## **IMPORTANT SAFETY RECALL – 16V-435**

## SN641

SUBJECT: Eaton Hydraulic Motor

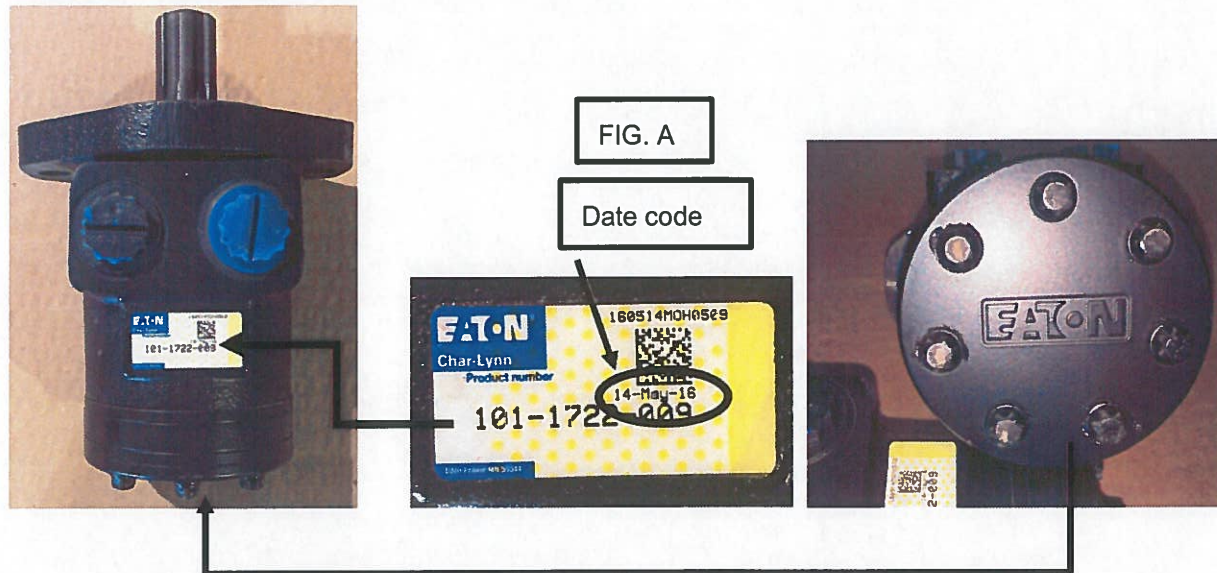
Locate the unit rotation hydraulic motor on the unit rotation gear box, the material handling jib winch hydraulic motor at the boom tip, or the front bumper winch hydraulic motor. Inspect the date code on the hydraulic motor tag. Reference FIG. A to identify the date code.

**Any EATON hydraulic motor with a date code between 26-Dec-15 and 30-Mar-16 is subject to the recall and will need the hydraulic motor replaced.**

Any EATON hydraulic motor with a date code before 26-Dec-15 or after 30-Mar-16 is not subject to this recall. Any hydraulic motor other than Eaton is not subject to this recall.

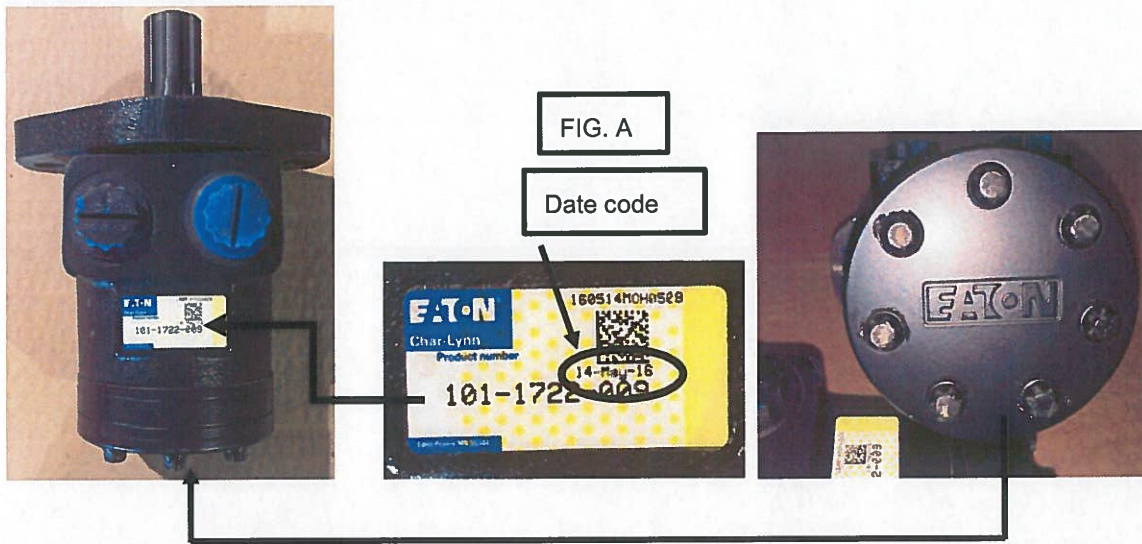
Locate the unit rotation hydraulic motor on the unit rotation gear box, the material handling jib winch hydraulic motor at the boom tip, or the front bumper winch hydraulic motor. Inspect the date code on the hydraulic motor tag. Reference FIG. A to identify the date code.

**Any EATON hydraulic motor with a date code between 26-Dec-15 and 30-Mar-16 is subject to the recall and will need the hydraulic motor replaced.**

Any EATON hydraulic motor with a date code before 26-Dec-15 or after 30-Mar-16 is not subject to this recall. Any hydraulic motor other than Eaton is not subject to this recall.
